Independent Technical Review of Management of Stormwater and Wastewater at the Separations Process Research Unit (SPRU) Disposition Project, New York

Prepared by: The DOE EM Center for Sustainable Groundwater and Soil Solutions, Savannah River National Laboratory, Aiken SC

June 2011

Figure 7: Contractor Proposed Stormwater Management System with Rail Bed Discharge.

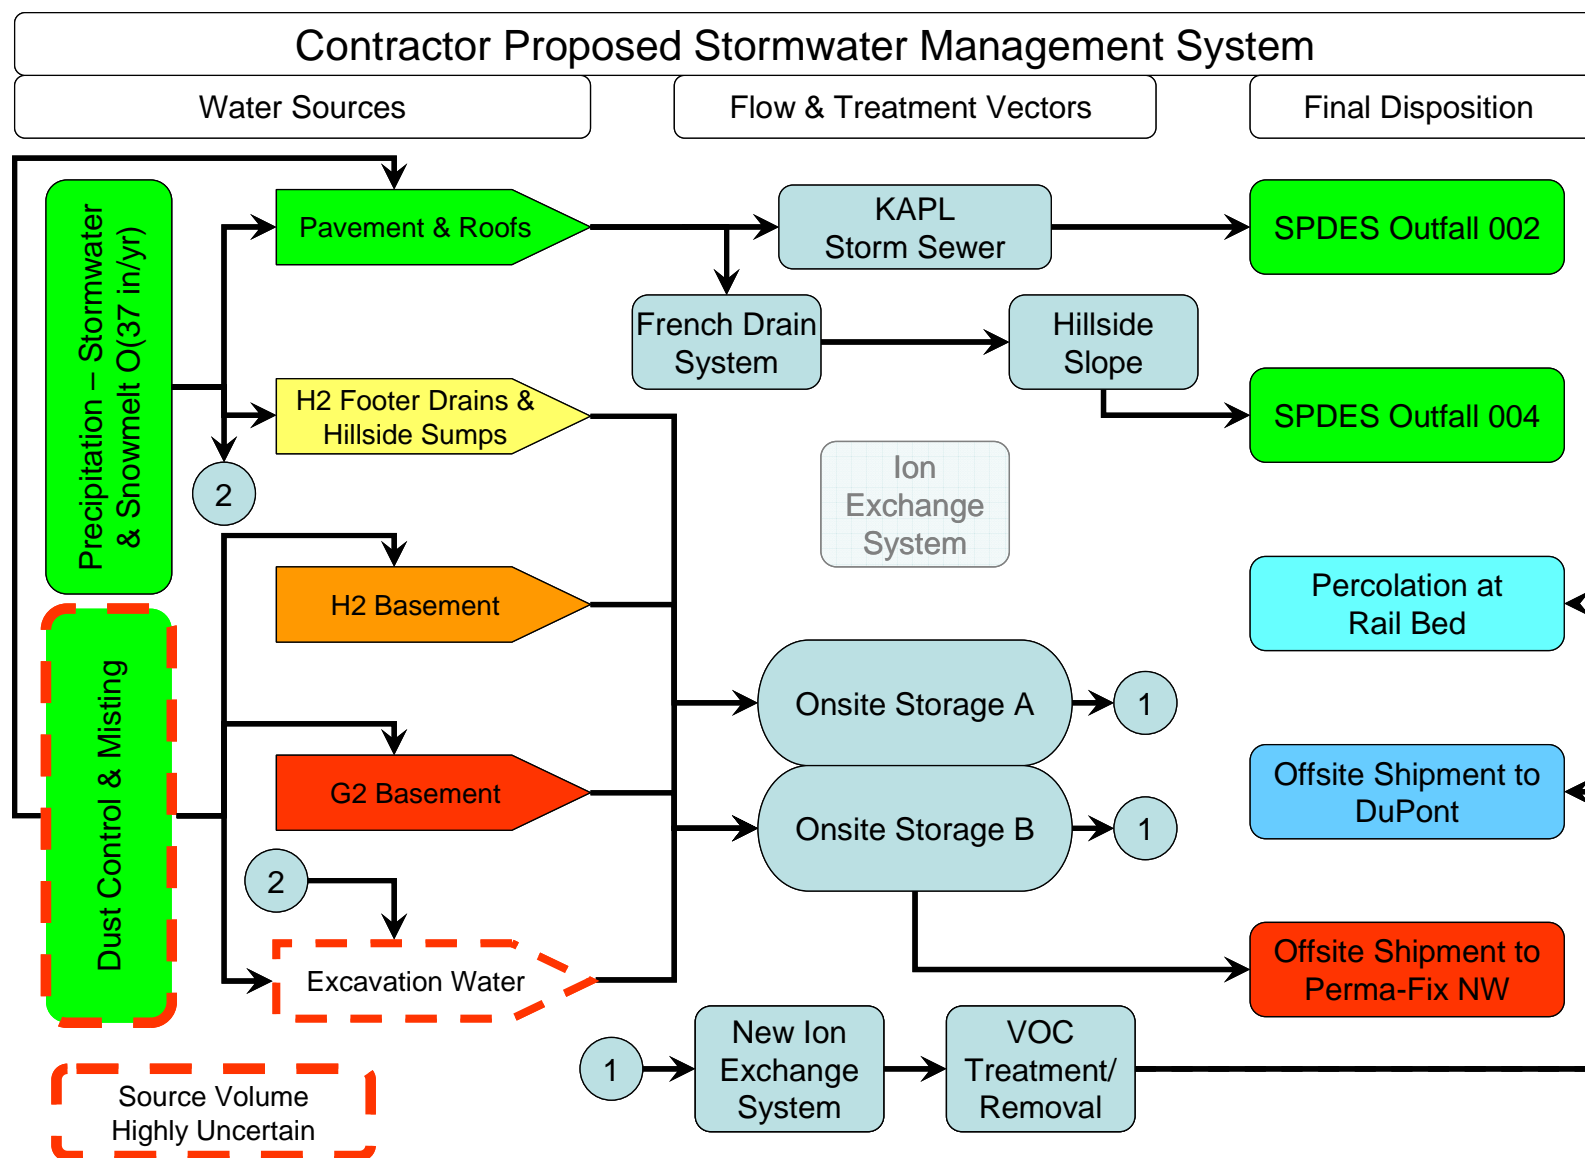
URS has proposed a stormwater management strategy to handle the surface water when D&D activities are restarted. This system is presented on Figure 7. Precipitation falling on the proposed tent structure over Building H2 will be transferred to the KAPL storm sewer through the old stormwater inlet on the SW corner of Building H2. Rainfall on the

Precipitation will also generate wastewater in the Hillside sump and the excavations that will be created to remove the subgrade structures of G2 and H2. These wastewater streams, along with water that has collected in the basements of Buildings G2 and H2 from D&D misting operations within the fabric enclosures (and later from rain when the fabric enclosures are removed), will be conveyed to holding tanks and processed through a proposed ion-exchange and VOC treatment system. Most water is expected to be treated to a level that would allow percolation of the water into the abandoned rail bed, but this requires approval from the State of New York and the treated water may be shipped to DuPont NJ during the approval process. Some of the contaminated water from the basement may be directly shipped offsite if the contaminant levels are too high for efficient treatment.

- Temporary siding and roof structures should be installed on Building G2 to minimize stormwater from entering the facility
- Strong consideration should be given to an enclosure over the entire H2 facility including the tank vault enclosure and access doors on north and south ends. This enclosure should reduce infiltration to H2 footer drains and basement.
- All areas around Building H2 and the Tank Vault should be sloped away from the structure to minimize the generation of wastewater from precipitation that enters the H2 footer sump, which drains to the Hillside sump.
- Impermeable geotextile should be placed under the French drains to eliminate percolation of stormwater into the H2 footer sump and KAPL storm sewer.

- All surfaces that are not part of the French drain system should be made impervious to the infiltration of precipitation. The “swamp mats” or asphalt can be used as effective materials to create localized impervious surfaces. Current use of swamp mats east of the H2 tank farm can be improved with grading away from sensitive areas and, if cost effective compared to asphalt, use should be expanded to other areas of the site.
- The stormwater management program needs to incorporate inspections from SPRU contractors that consider excess wastewater generation from stormwater events.
- Onsite collection and storage of stormwater from roofs and enclosures should be considered to minimize loading to French drains and provide beneficial reuse of collected water.
